Ohio Department of Natural Resources
DNR-250014 Mary Jane Thurston State Park Tree House Cabins
1466 State Route 65, McClure OH 43534, Wood County

ADDENDUM 06

Date of Addendum: 1/23/2026

1 **COMPLEX - COMMUNITY PLATFORM PLAN**
1/8" = 1'-0"

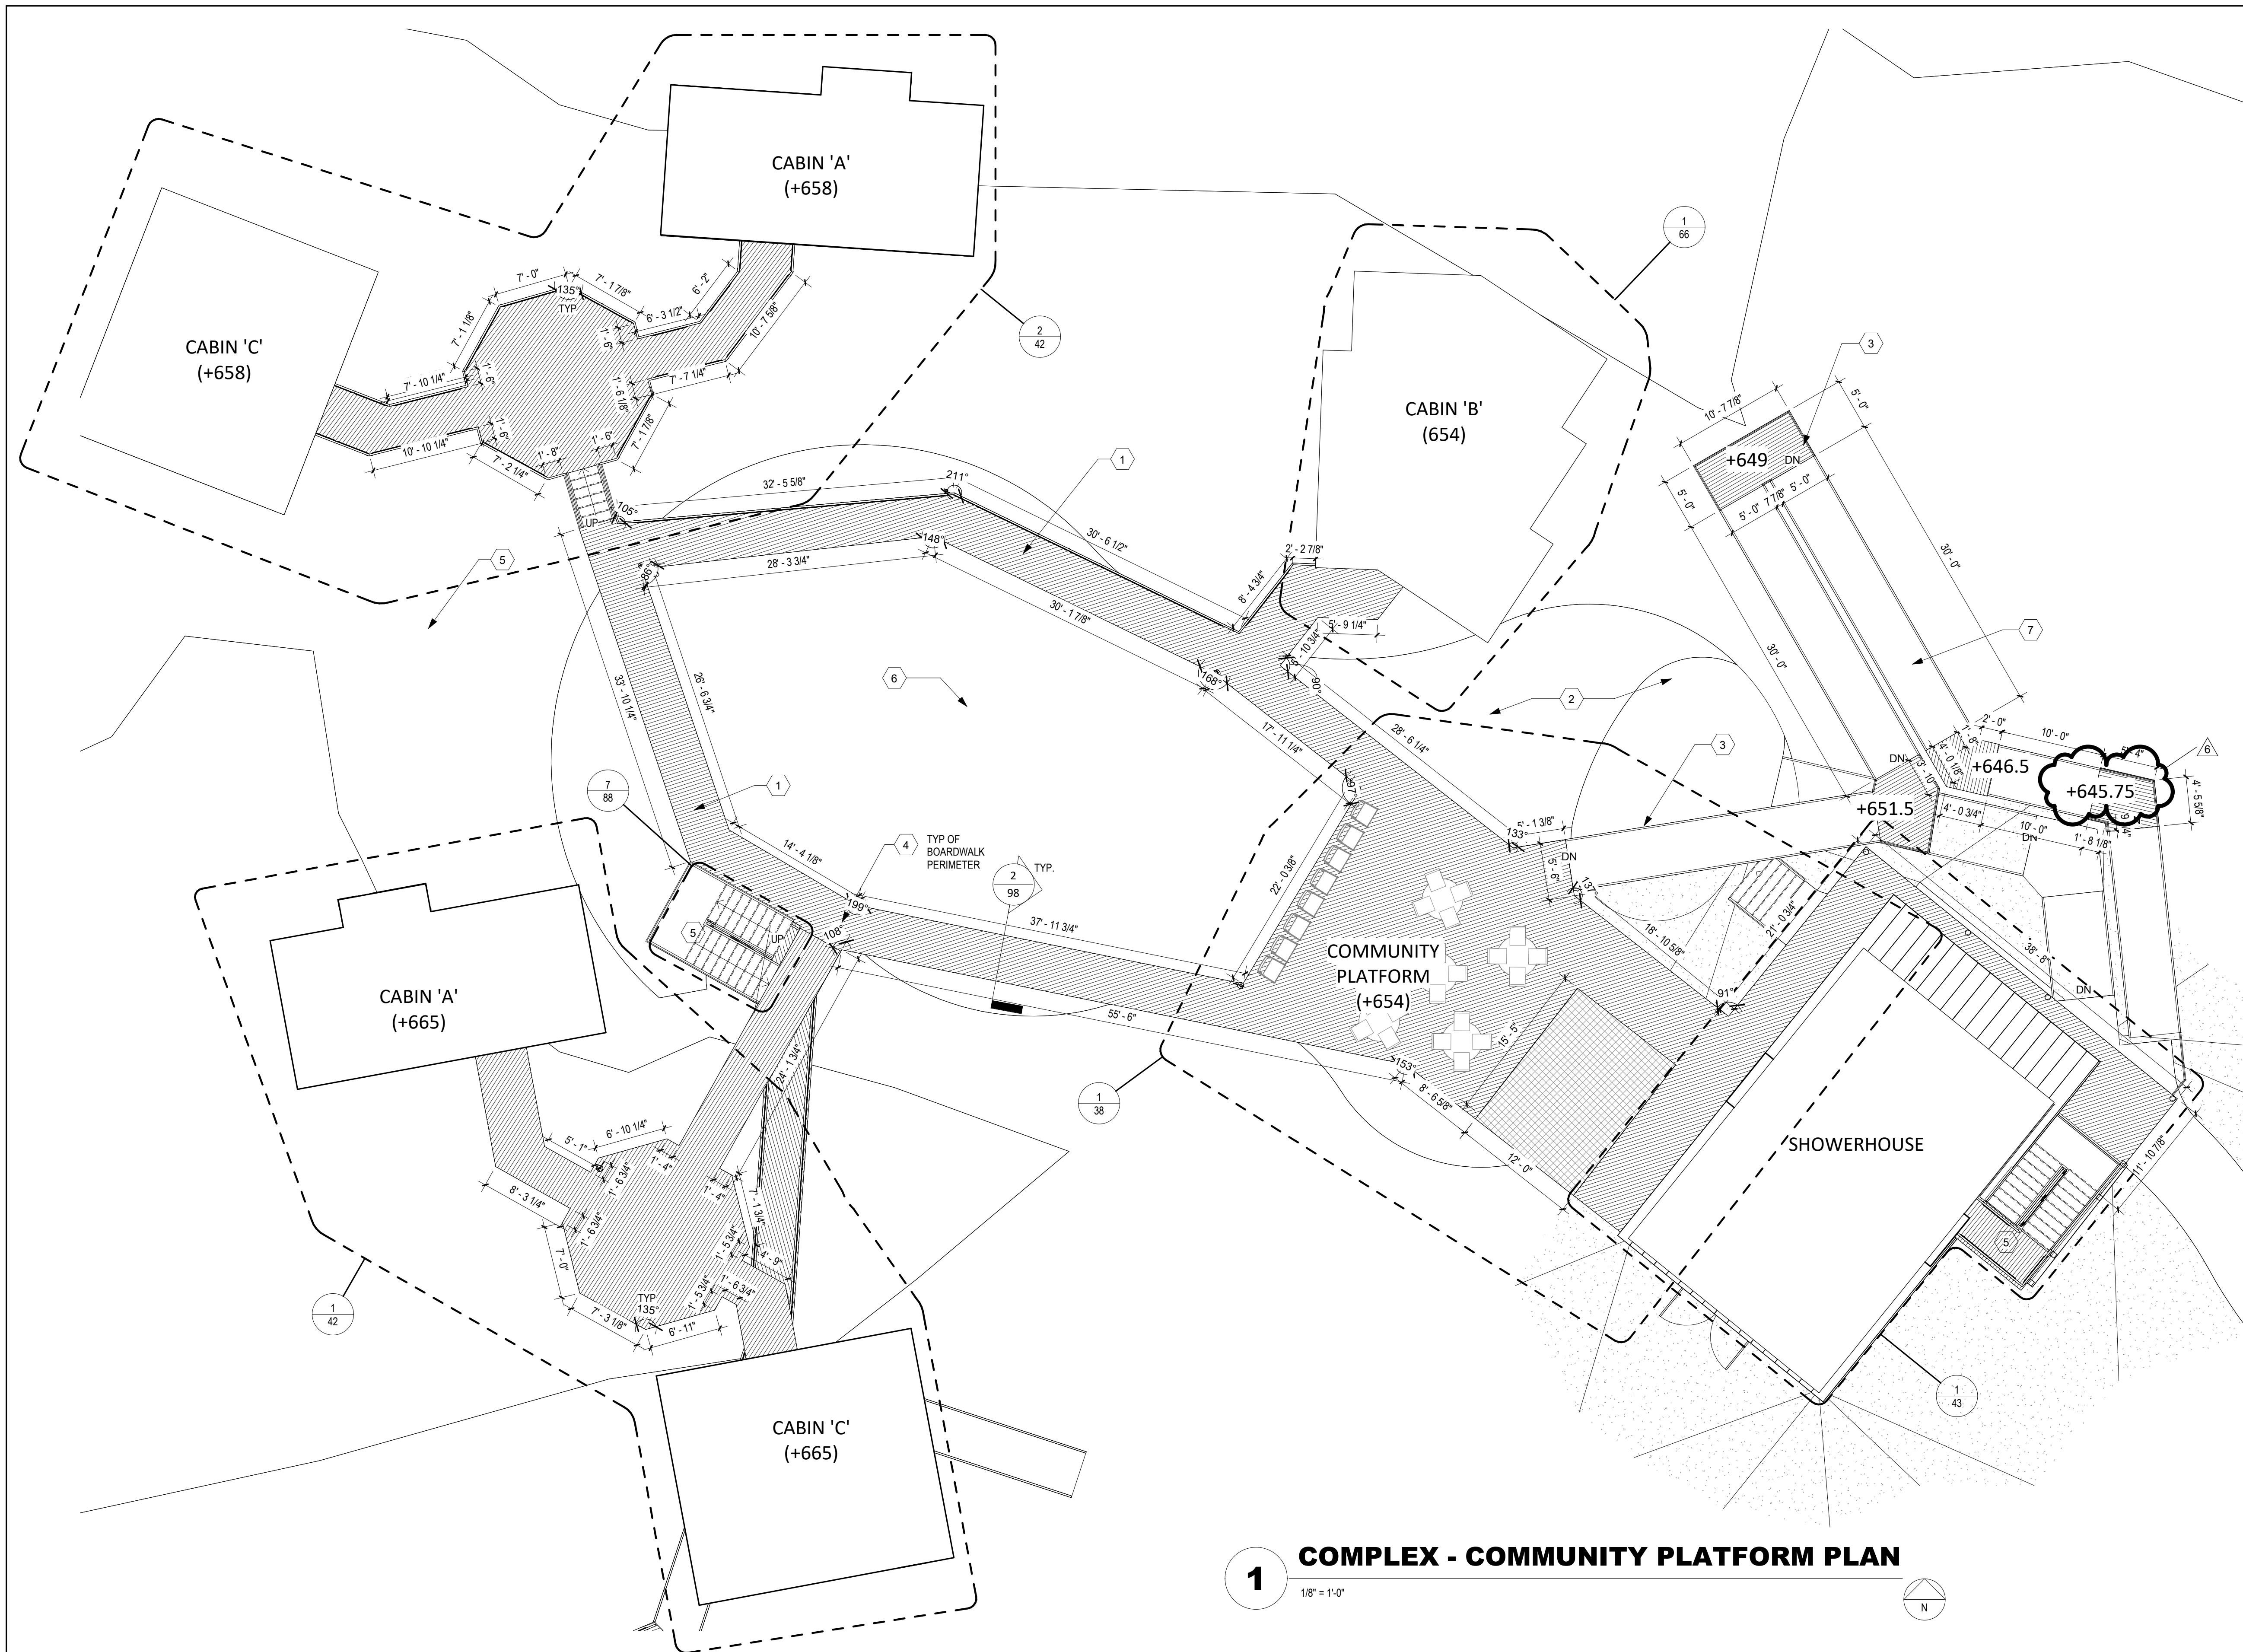
14. Sheet 37 COMPLEX - COMMUNITY PLATFORM PLAN: Replace sheet in its entirety with attached.
15. Sheet 52 SHOWERHOUSE – PERSPECTIVES: Remove sheet in its entirety.

1 CABIN A - FIRST FLOOR PLAN
1/2" = 1'-0"

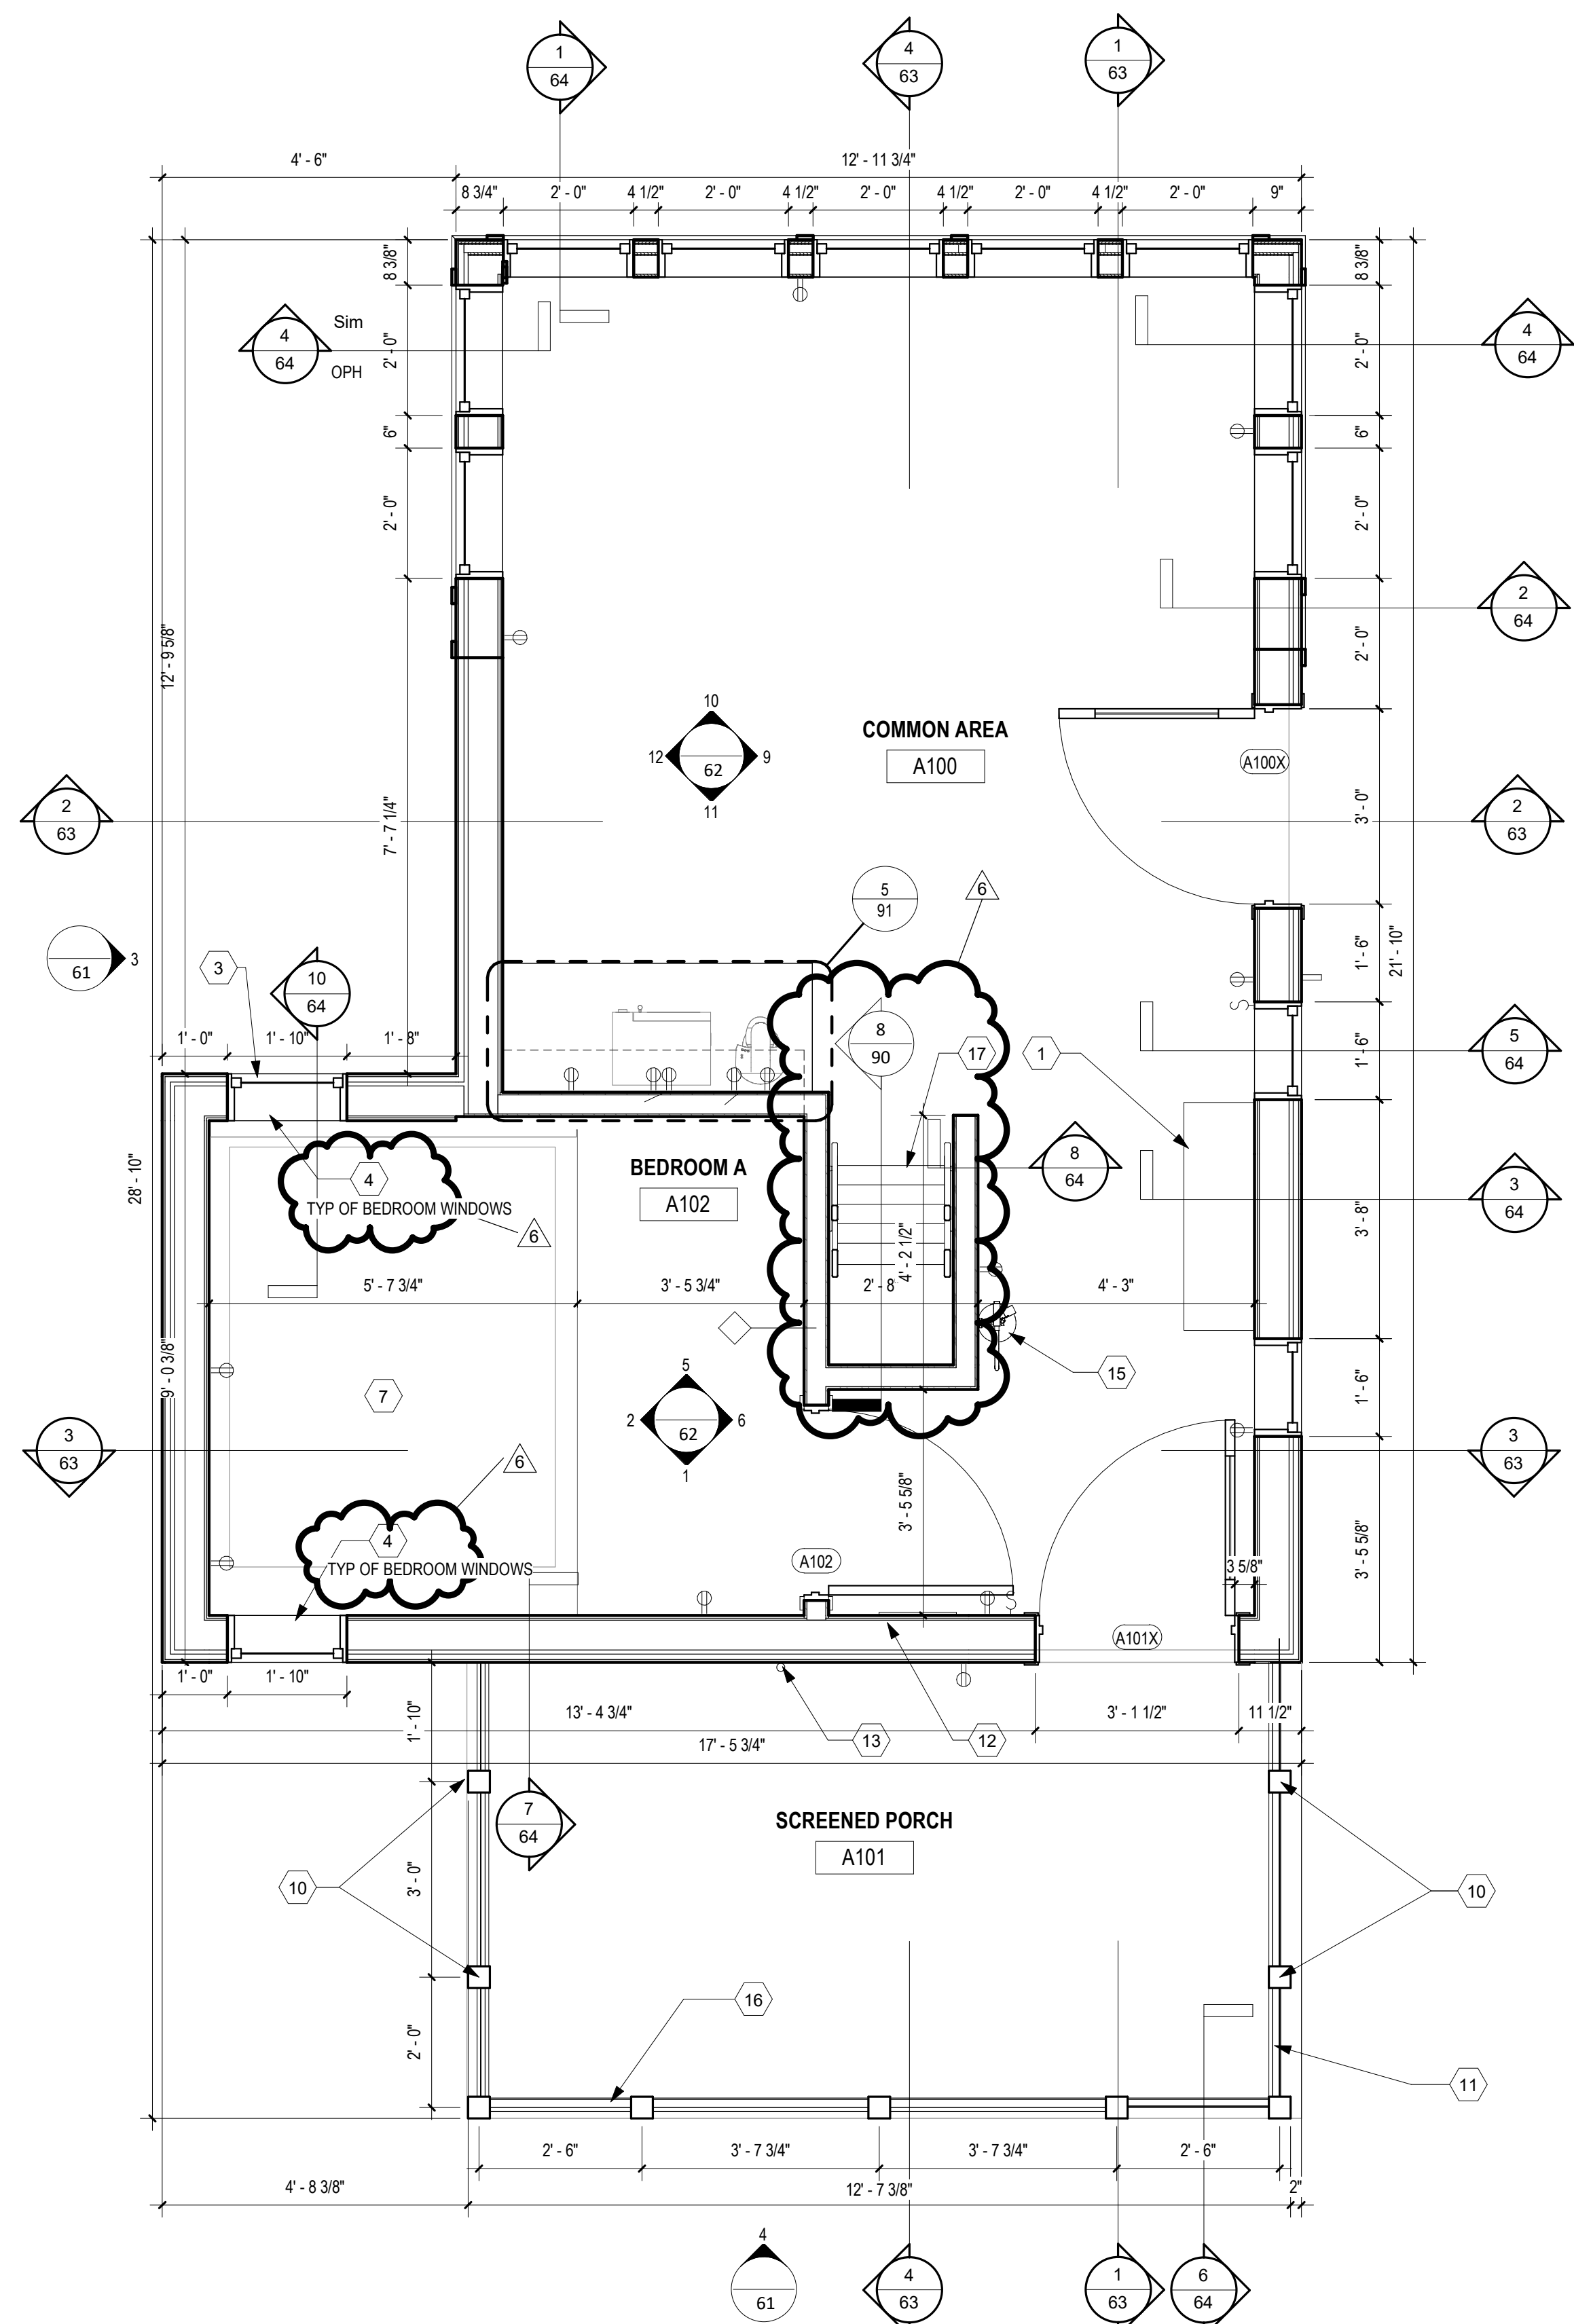
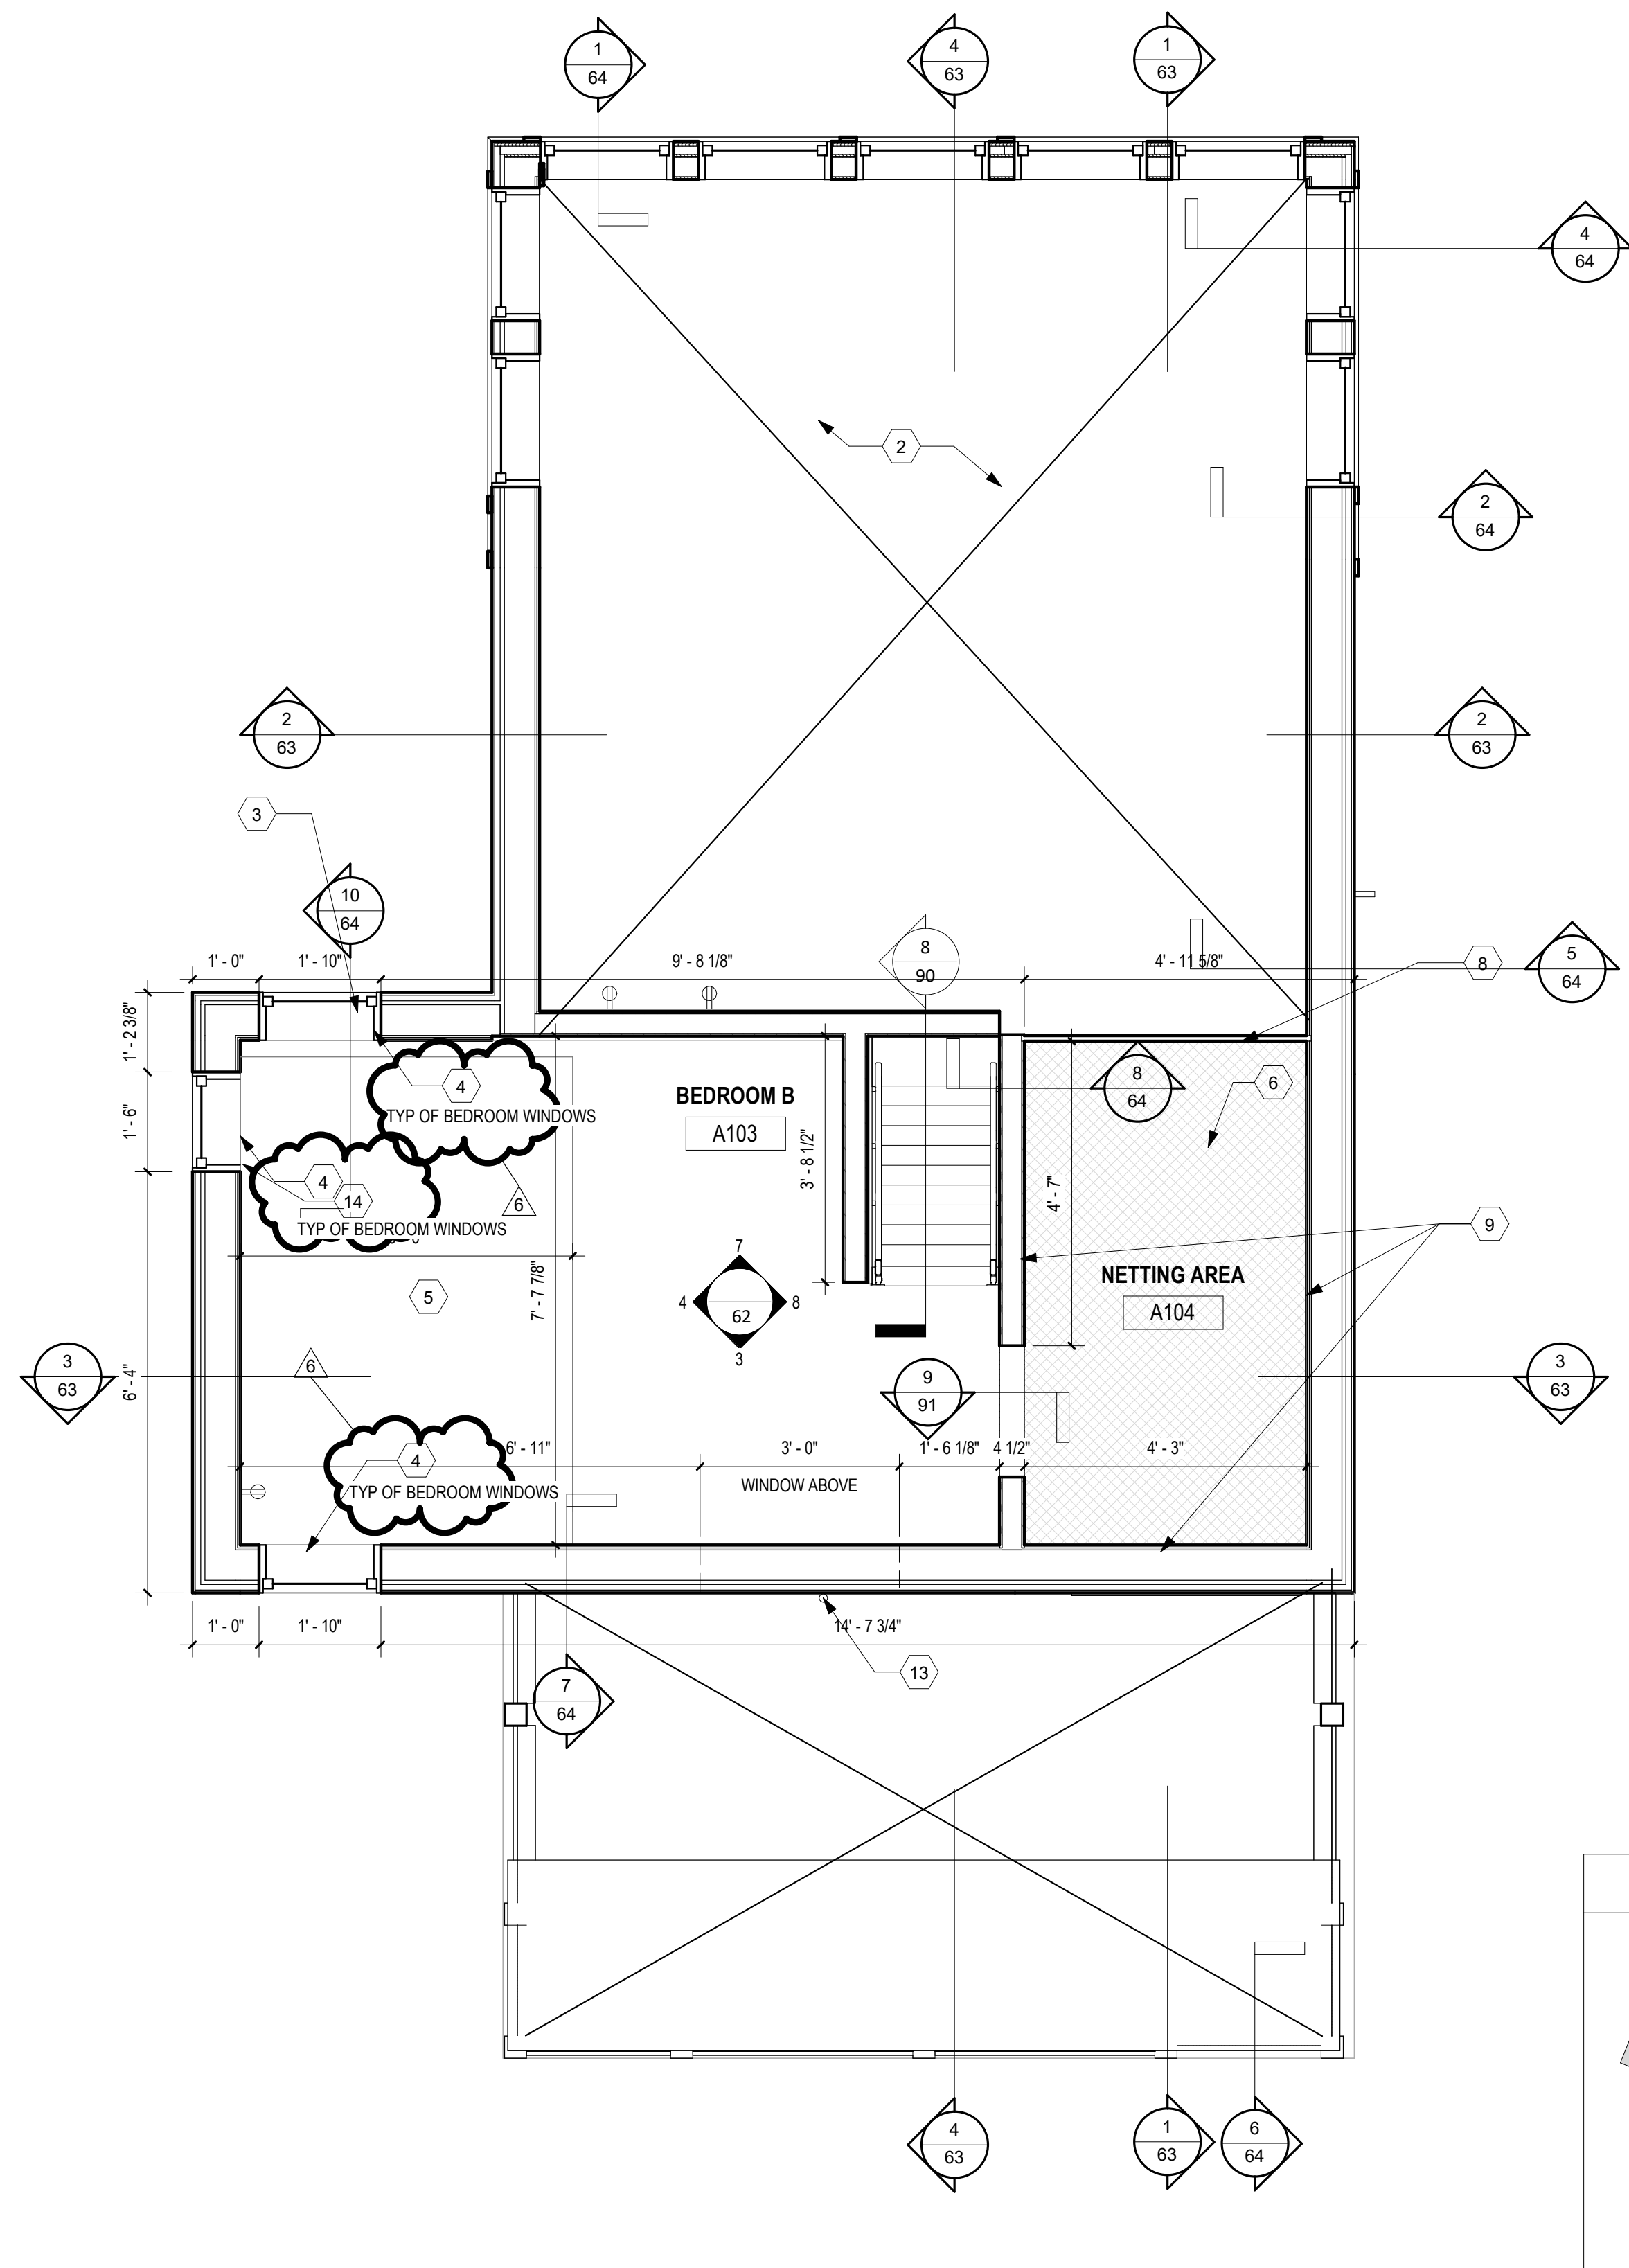
16. Sheet 58 – CABIN A – FLOOR PLAN: Replace sheet in its entirety with attached.
17. Sheet 61 – CABIN A - ELEVATIONS: Detail 4, Replace window tag “W10” with “W20”.
